Dodge Truck Adapter Harness Technical Service Bulletin

Old

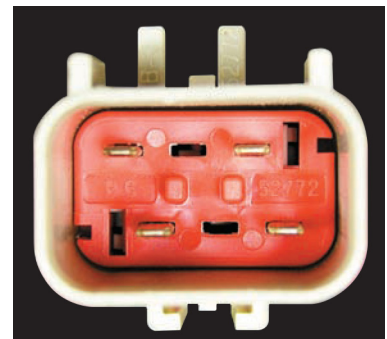
Several fuel pump assembly applications for 1996-1997 Dodge trucks contain an adapter harness to plug into the original vehicle wiring harness.

The adapter harness on the replacement fuel pump assembly has a 4-pin connector, which differs from the 6-pin connector on the original fuel pump assembly.

The original fuel pump assembly unit only uses 4 of the 6 pins in the connector. The vehicle harness, though containing 6 pins, only uses 4.

- The OE vehicle harness mates with the replacement unit adapter plug.
- Though they differ in appearance, the mating connectors are correct and perform to the OE specification.
